# ST. MARY'S HOSPITAL

December 24, 1979

This is in reference to your letter dated December 6, 1979 concerning Teletherapy License No. 45-11367-01; Control No. 01321. The information requested is provided below:

(Source in "OFF" position.  
Measurements taken one meter  
from source)

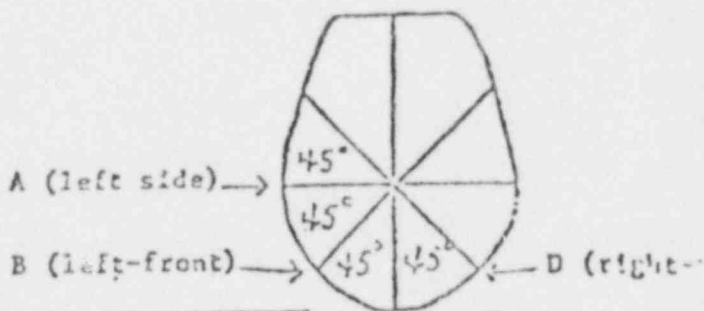
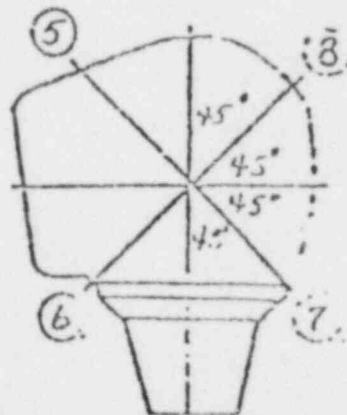
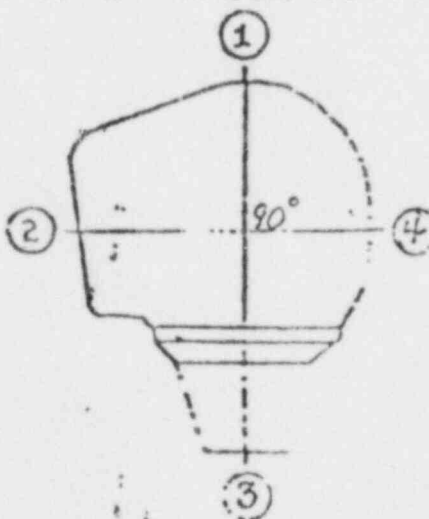
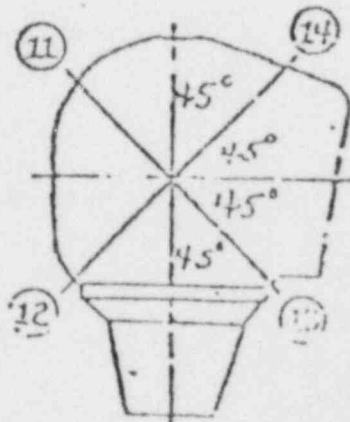
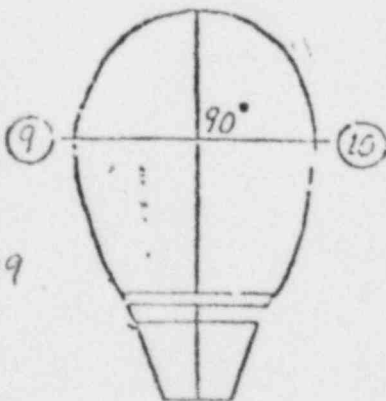
1. A revised survey of the leakage radiation from the source head has been made in the off position and our new report is enclosed. These values were obtained with the collimators completely closed throughout the survey. It appears that at the time of the previous survey (our letter dated May 26, 1978), the collimators were not completely closed except when the reading at point 3 was taken. In view of the revised data, we are convinced that the average leakage radiation level will not exceed the 2 mR/hour value when an 8600 curie source is loaded into the unit. Incidentally, according to Neutron Products, Inc. from whom we will purchase the source, stated that the maximum activity of the source will be 8600 curies. We requested renewal of the license to include two sources each of 9000 curies to allow for some margin.

SOUTH ELEVATION OF COBALT RM.

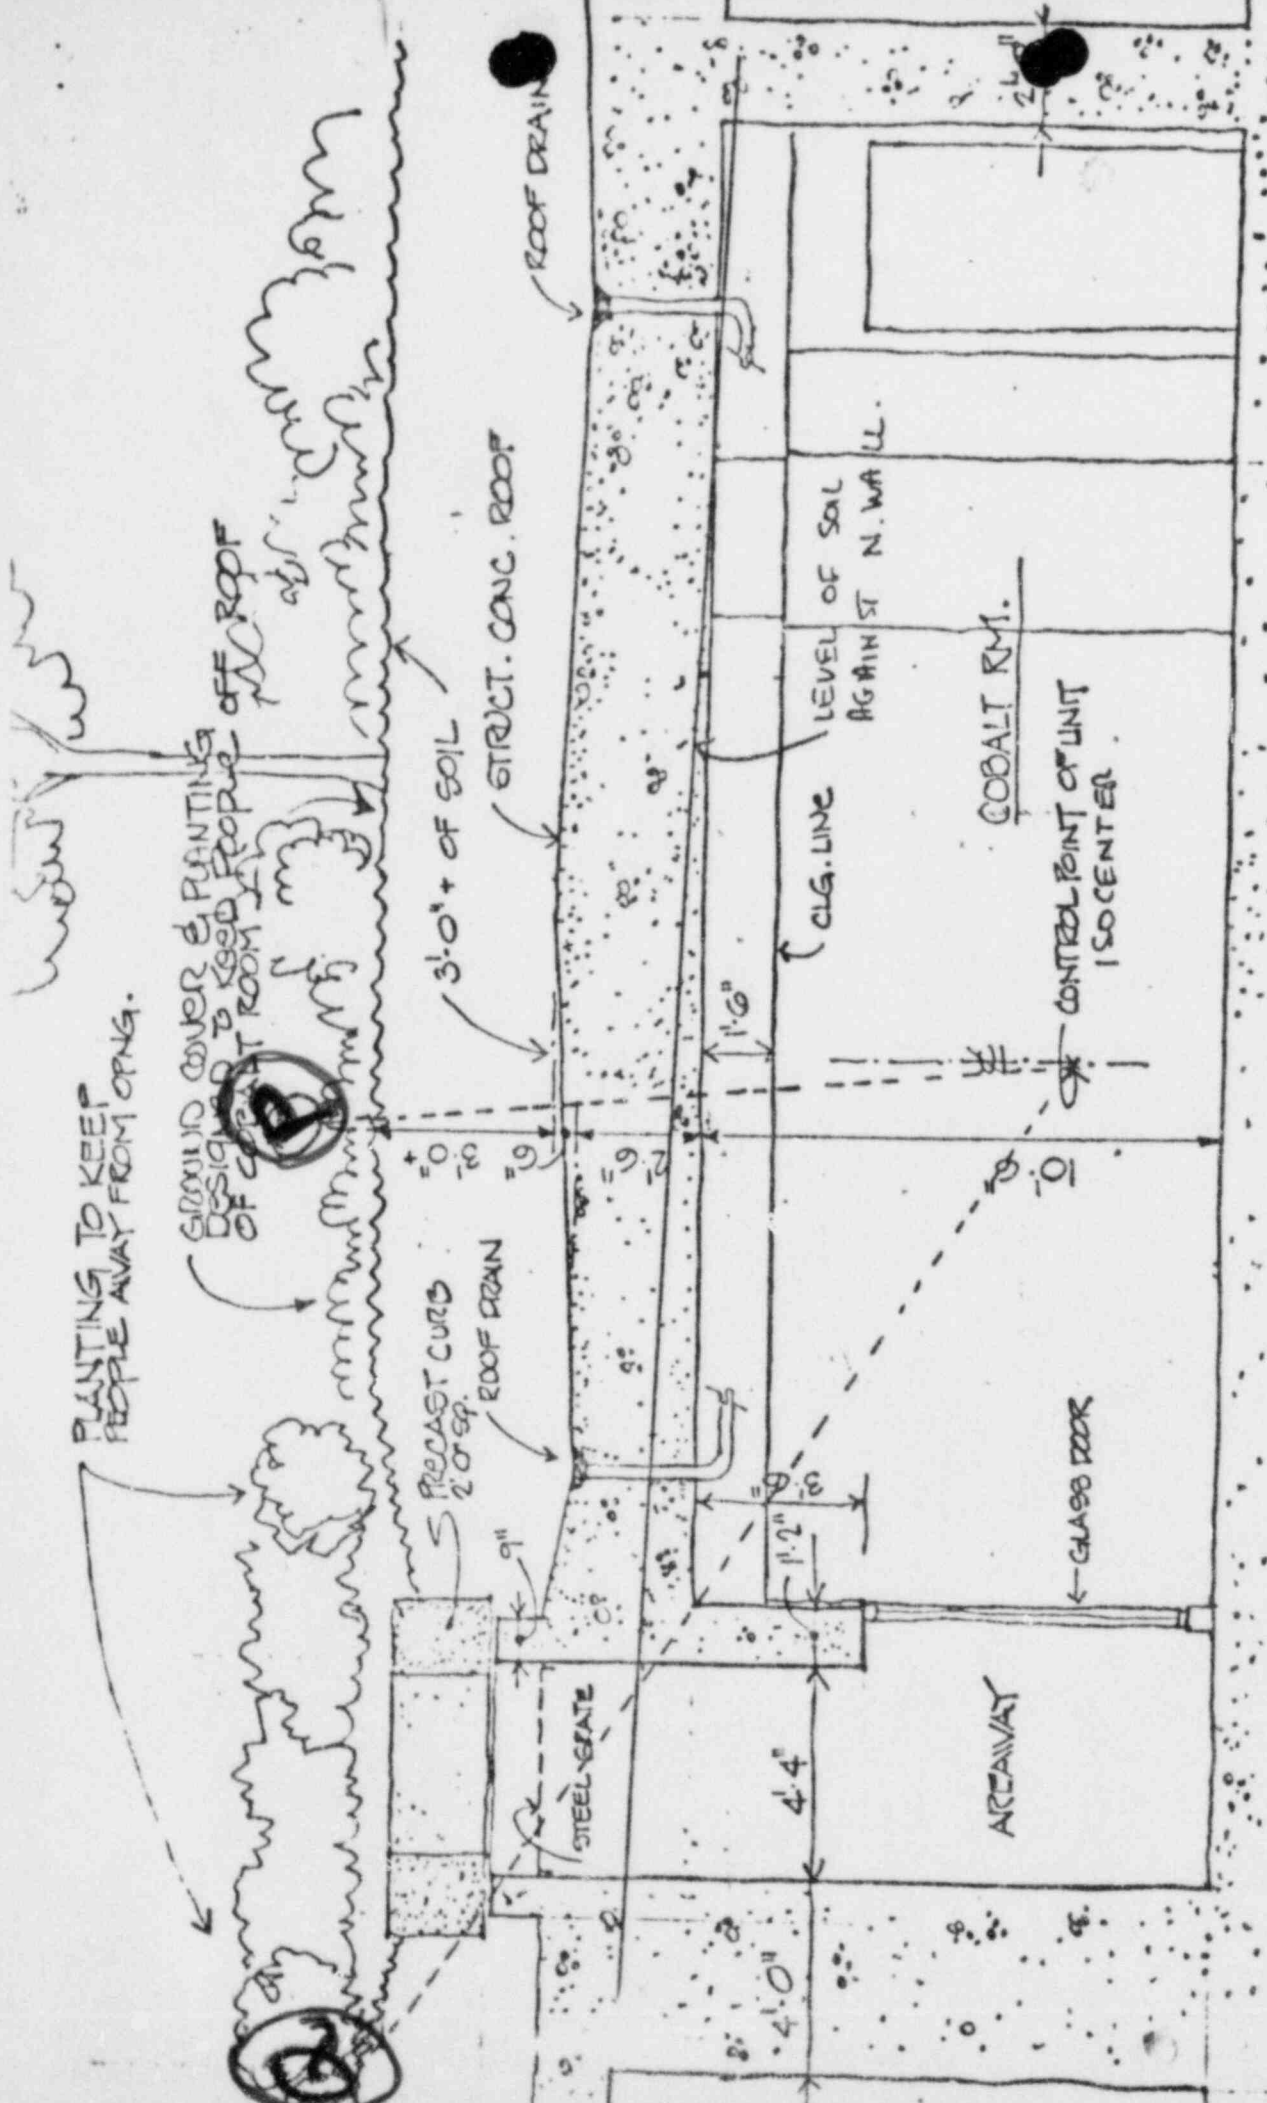
- 2&3. Enclosed are drawings showing the floor plan and elevation of the cobalt room and the immediate surroundings. The radiation levels expected with a 8600 curie source at various locations marked in these diagrams are as follows:

<u>Location</u>	<u>Measured Maximum Radiation Level (mR/hr)</u>	<u>Maximum Radiation level in any one hour (mR)</u>	<u>Maximum Radiation level in any seven consecutive days (mR)</u>
J	< 0.08	< 0.012	< 0.48
K	< 0.08	< 0.012	< 0.48
L	< 0.08	< 0.012	< 0.48
M	< 0.08	< 0.012	< 0.48
N	< 0.08	< 0.012	< 0.48
O	< 0.08	< 0.012	< 0.48
P	< 0.08	< 0.012	< 0.48
Q (Atrium)	4 (?)	0.6	24

If Q has 12mR/hr  
we expect from  
1978 survey of  
ca 0.15 hr on/h then  
12 x 0.15 = 1.8 mR in any 1 hour  
OK w/ 2/10/85 (1) JCV

The measured maximum radiation levels recorded above were obtained by direct measurement with the existing source (2239 curies) and proportionately increased to obtain projected values for the proposed 8600 curie source. They were obtained with the maximum field size and a water phantom in the beam. Thus they indicate the total leakage and scattered radiation levels. The primary beam is always intercepted by the beam stopper. Each reading was obtained with a beam orientation that results in the maximum value at that location.
